VALUE ENGINEERING STUDY REPORT

Operations Buildings Poplar Island

Baltimore District US Army Corps of Engineers

17 March 03

E - 01

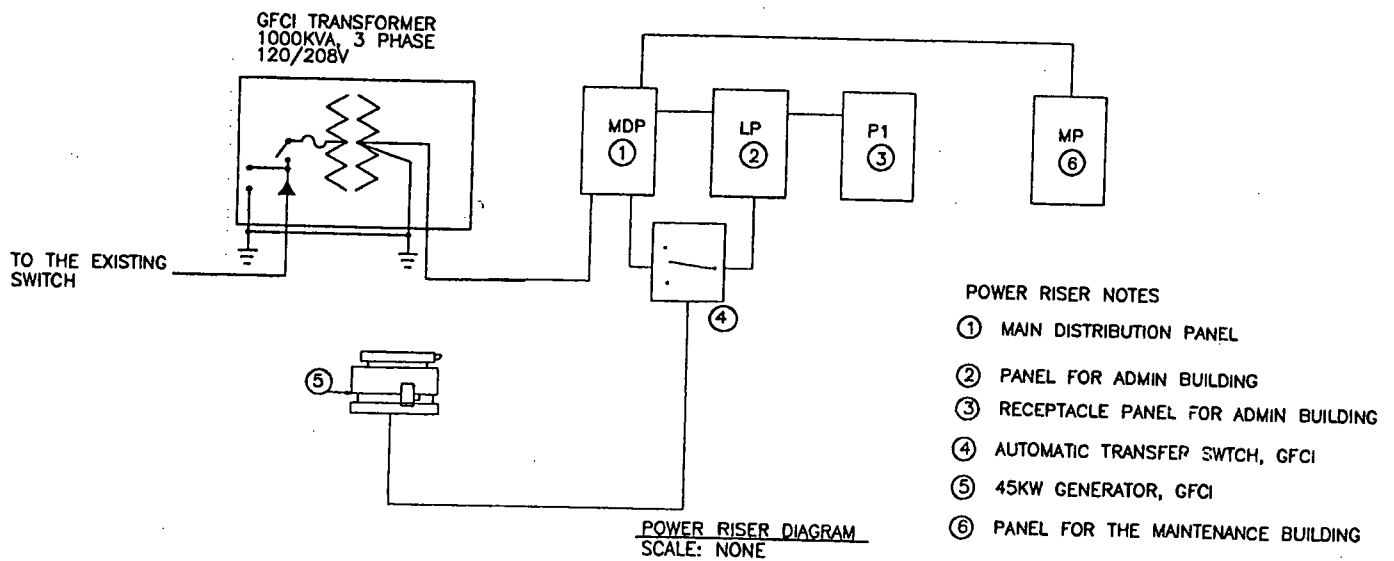
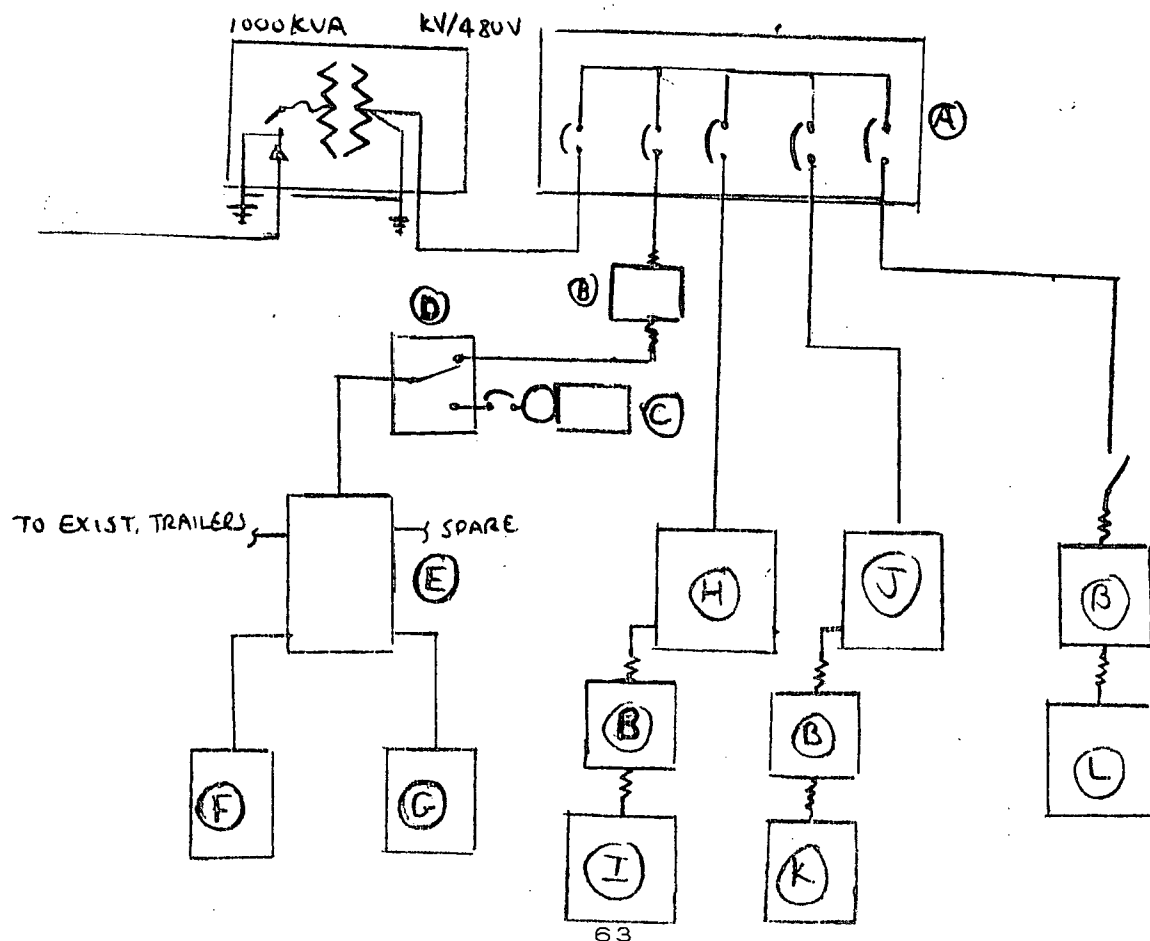
DESCRIPTION: Develop an electrical master plan.

PROPOSED DESIGN: Develop a site master plan to include provisions for the distribution of emergency and non-emergency power to the various site loads. See proposed sketch for an example.

If a central power distribution switchboard is required for the site, it can be incorporated in this project, minimizing future cost. The central power distribution switchboard can be used to distribute emergency power, if required.

The existing design does not consider the present and future site loads. The electrical service schematic only includes new work. The adequacy of the emergency generator is unknown without some definition of the emergency power requirements throughout the site.

M - 02

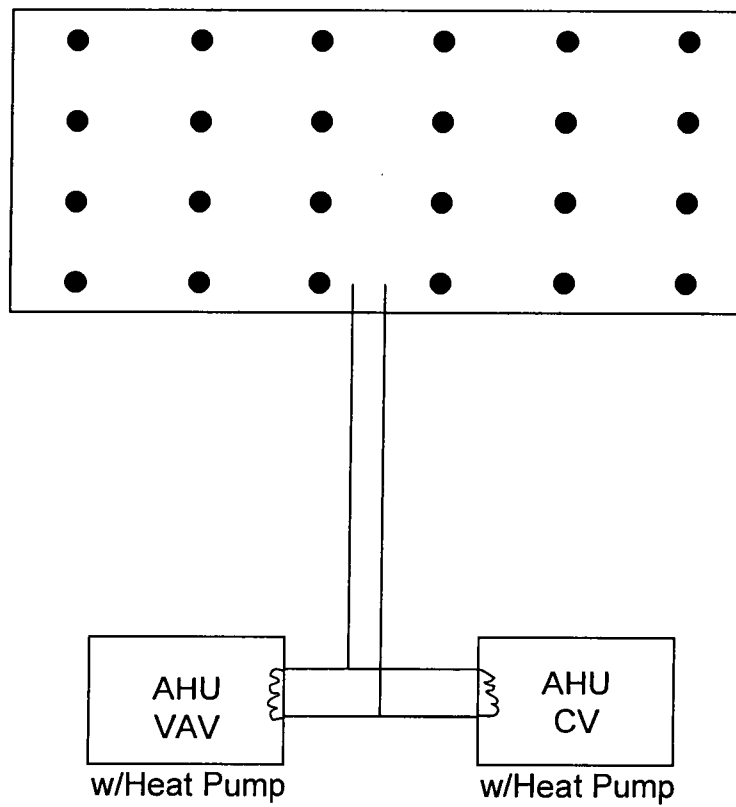
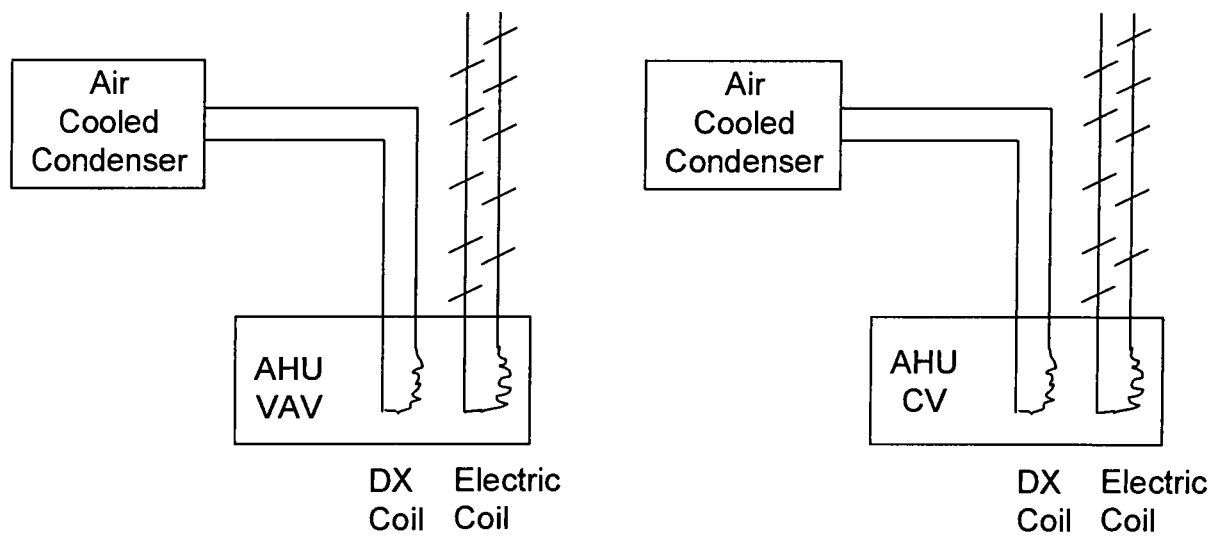
DESCRIPTION: Use electric heat. Delete ground source heat pump.

ORIGINAL DESIGN: Heat pumps provide 55F air to the two air handling units. Electric reheat in the VAV boxes provide additional heating when needed.

PROPOSED DESIGN: Use electric heating coil and DX cooling coils in lieu of heat pumps in the air handling units. Delete the ground source heat pump wells.

JUSTIFICATION: The ground source heat pump is not the right application for this project. The HVAC load for this project is small. The two heat pump units provide a total of 23 ton of cooling and 90 MBH of heating. This can be more economically provided by DX cooling and electric heat. The cost of bringing drilling equipment out to the island to install a few ground source wells will not be economical.

M - 03

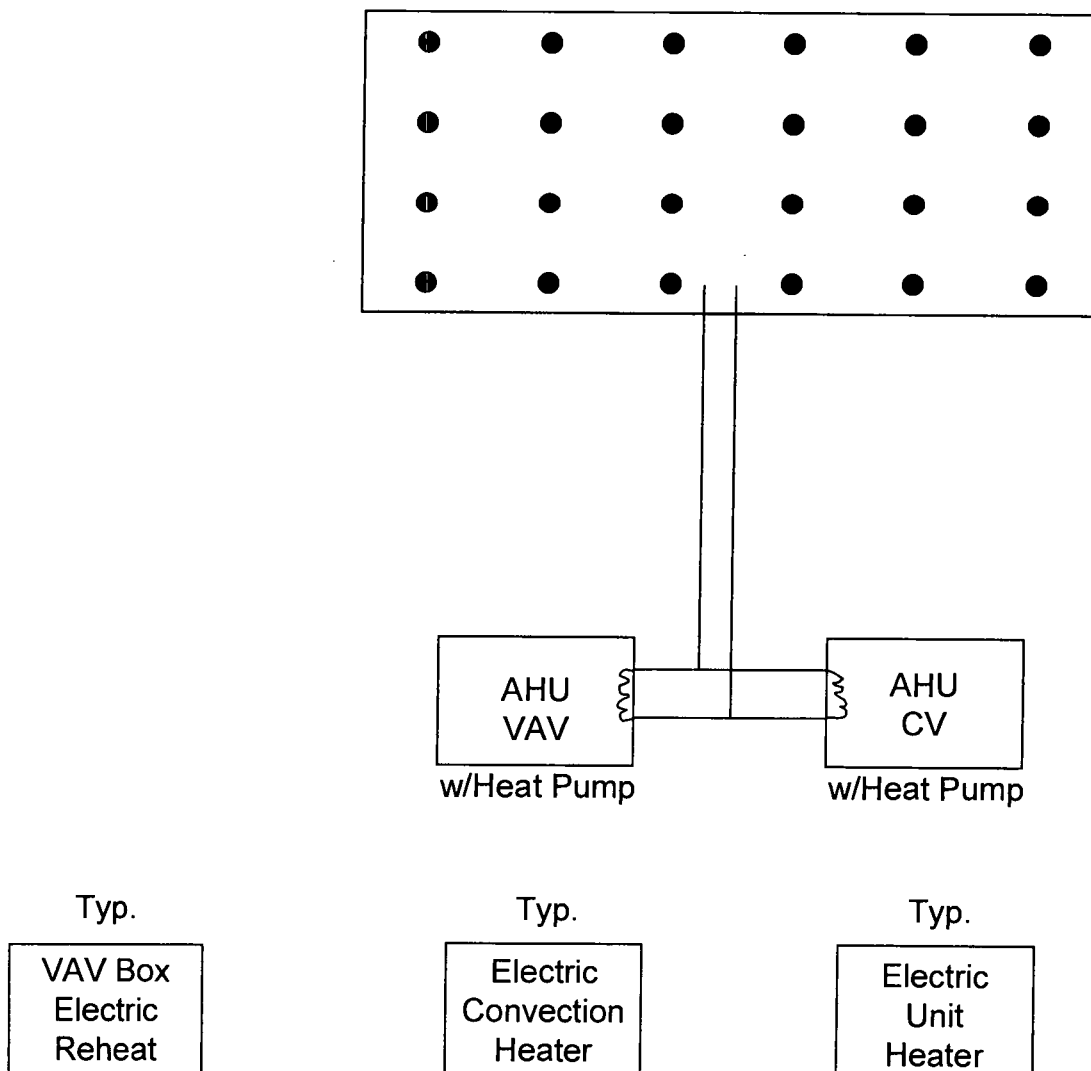
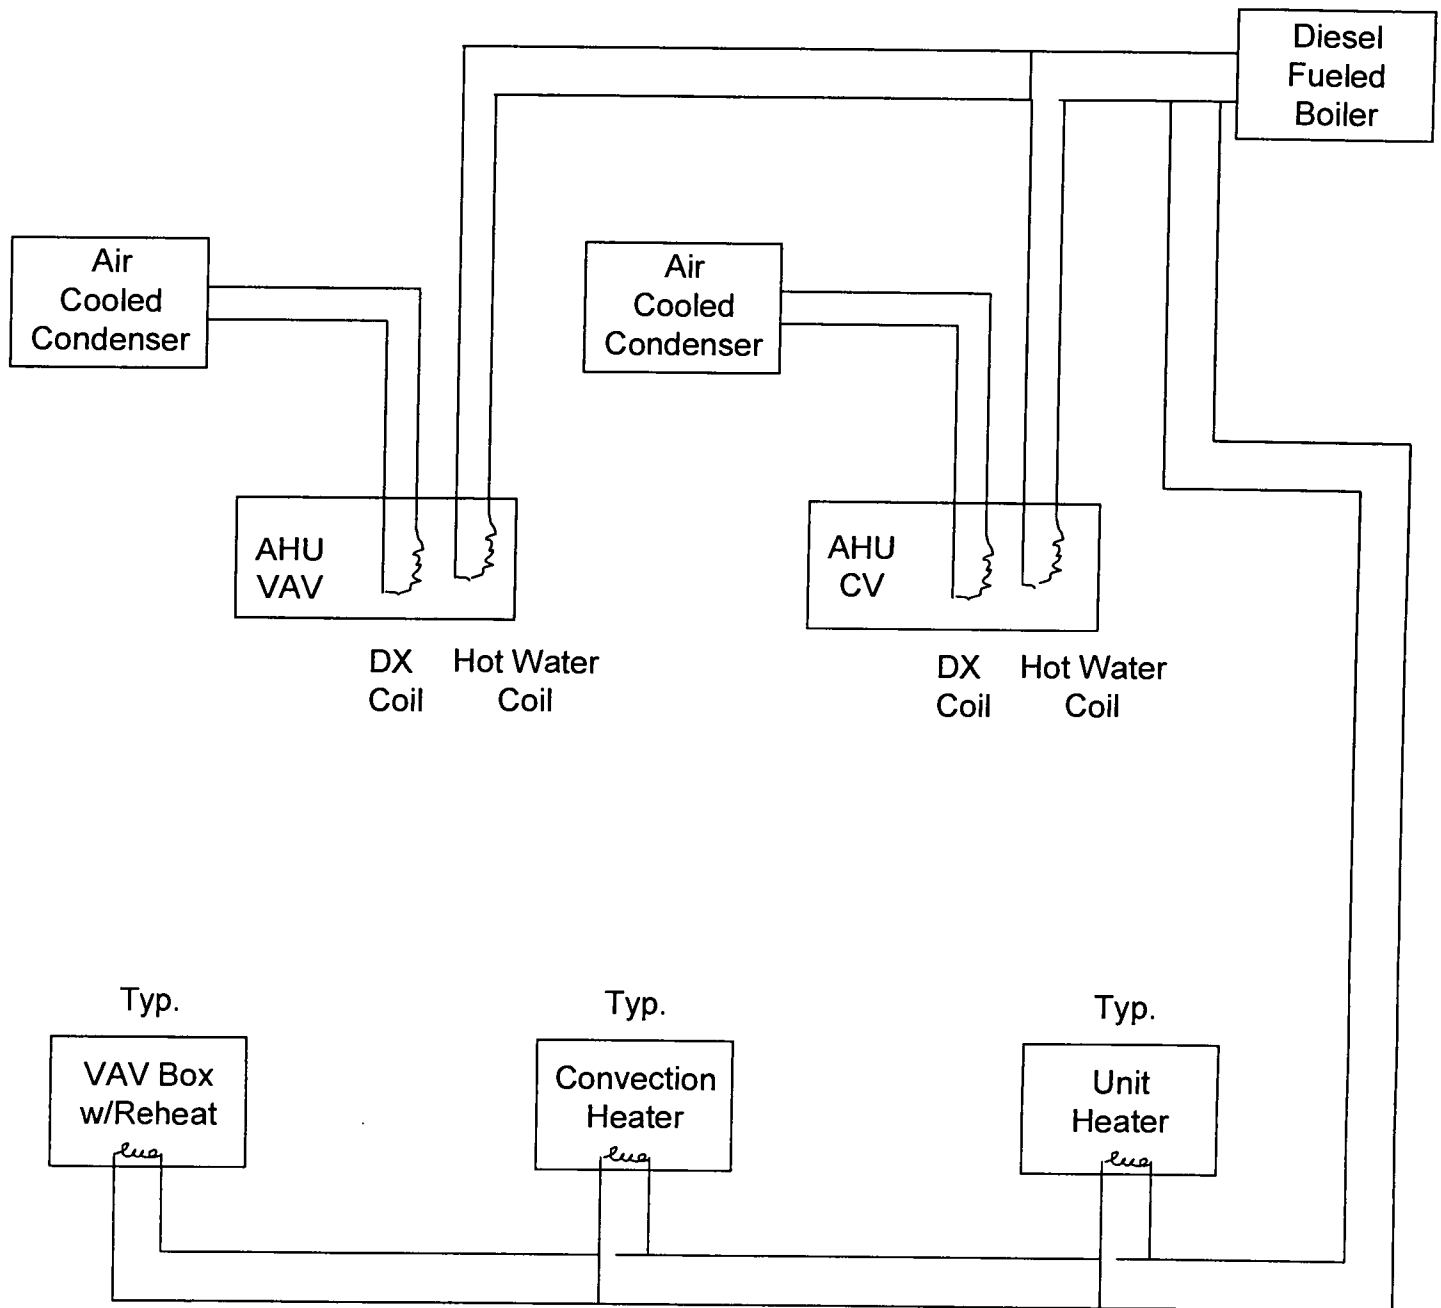
DESCRIPTION: Use diesel fuel for heating. Delete ground source heat pump.

ORIGINAL DESIGN: Heat pumps provide 55F air to the two air handling units. Electric reheat in the VAV boxes provide additional heating when needed.

PROPOSED DESIGN: Use hot water heating coil and DX cooling coils in lieu of heat pumps in the air handling units. Provide diesel fuel fired hot water boiler in mechanical room. Delete the ground source heat pump wells.

JUSTIFICATION: The ground source heat pump is not the right application for this project. The HVAC load for this project is small. The two heat pump units provide a total of 23ton of cooling and 90 MBH of heating. This can be more economically provided by DX cooling and a diesel fueled boiler. The boiler can provide heating to the rest of the heaters, eliminating energy inefficient electric heating. The cost of bringing drilling equipment out to the island to install a few ground source wells will not be economical.

same fuel can be used in boilers to provide heating. There are currently three 8000 gallon diesel storage tanks on the island. One of which could store more than enough fuel for heating for the entire year.
